DUKE POWER COMPANY

Re: Catawba Nuclear Station  
Docket Nos. 50-413 and 50-414

CATAWBA NUCLEAR STATION  
ENVIRONMENTAL QUALIFICATION OF ELECTRICAL EQUIPMENT  
RESPONSE TO NUREG 0588

CATAWBA NUCLEAR STATION - UNITS 1 AND 2  
ENVIRONMENTAL QUALIFICATION OF ELECTRICAL EQUIPMENT  
RESPONSE TO NRC EQ AUDIT ITEMS

FIGURE 1

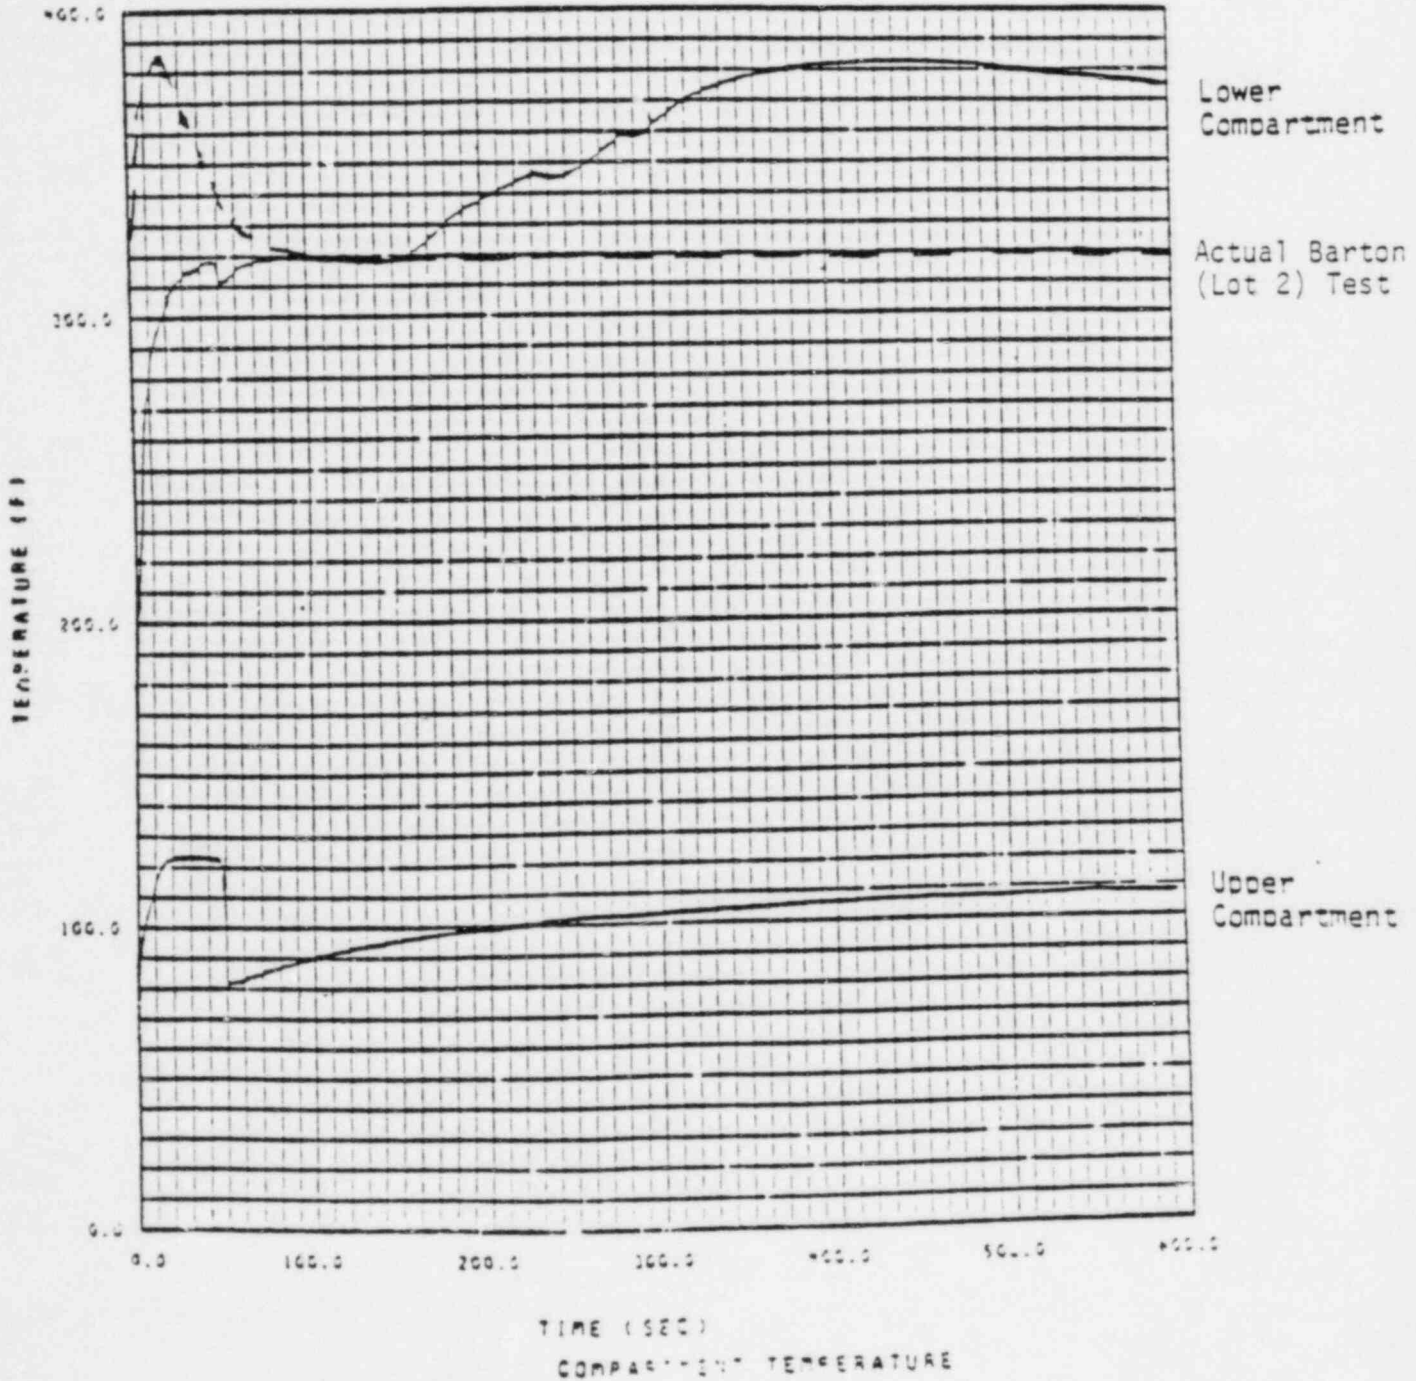
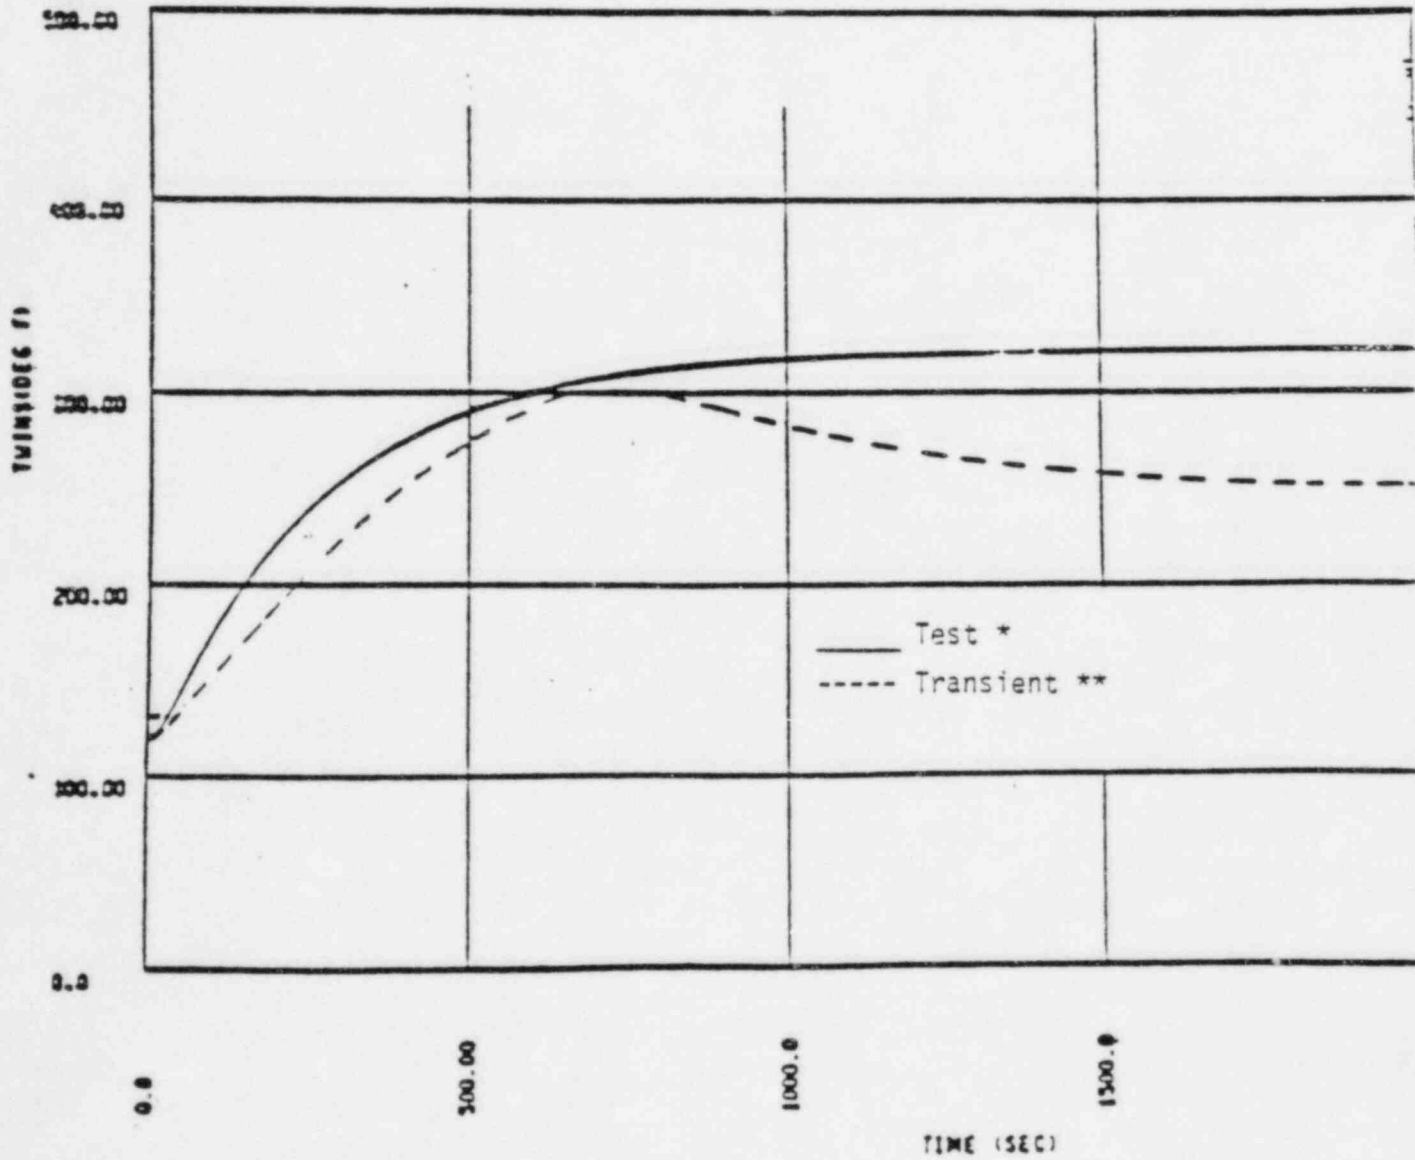
During the review of the Barton transmitter qualification report (WCAP 9885) the NRC requested additional information concerning the temperature profile of the qualification test. Specifically, the FSAR peak postulated accident temperature has a time duration of approximately 10 minutes versus the qualification test peak temperature duration of approximately 5 minutes.

Westinghouse has performed a thermal analysis of the transmitter which demonstrates that for a temperature/duration in excess of the Catawba accident environment, the internal transmitter temperature does not exceed the temperature experienced during the qualification test. This analysis coupled with the transmitter qualification program provides adequate assurance of qualification. Documentation necessary to support this thermal analysis is on file and available for audit at Duke Power Company.

The dashed curve of Figure 1 is the actual Barton test profile. The solid curve of Figure 2 is the calculated temperature inside the transmitter during the actual test analyzed out to 10 minutes. The solid curve of Figure 1 is the lower compartment postulated accident profile which envelopes the Catawba accident profile. The dashed curve of Figure 2 is the calculated temperature inside the transmitter during the postulated accident represented by the solid curve of Figure 1. These curves demonstrate that for a temperature/duration in excess of the Catawba accident environment, the internal transmitter temperature does not exceed the transmitter temperature experienced during the qualification test.
